Product / Process Change Notification (PCN)		
<input checked="" type="checkbox"/> Major Change <input type="checkbox"/> Minor Change		
PCN Number: PCN_UtFB3751_20241223 Affected Series: WE-FB Affected Order Codes: 750032051, 750032052 PCN Date: 2024-09-23 (YYYY-MM-DD) Effective Date: 2024-12-23 (YYYY-MM-DD)	Change Category: <input type="checkbox"/> Equipment/Location <input type="checkbox"/> General Data <input checked="" type="checkbox"/> Material <input type="checkbox"/> Process <input checked="" type="checkbox"/> Product Design <input type="checkbox"/> Shipping/Packaging <input type="checkbox"/> Supplier <input type="checkbox"/> Software	
Contact: Product Management Phone: +49 (0) 7942 - 945 5001 Fax: +49 (0) 7942 - 945 5179 E-Mail: pcn.eisos@we-online.com	Datasheet Change: <input type="checkbox"/> Yes <input checked="" type="checkbox"/> No Attachment: <input type="checkbox"/> Yes <input checked="" type="checkbox"/> No

Before:

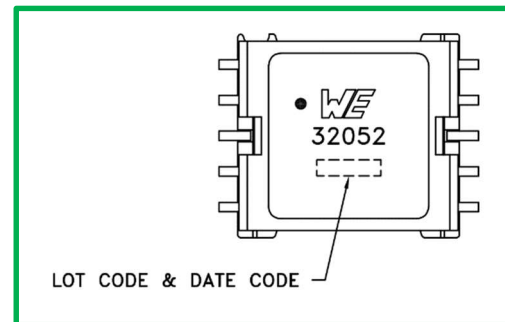
The solder suffix will be removed from the product marking detail. See before change in red and after change in green below.
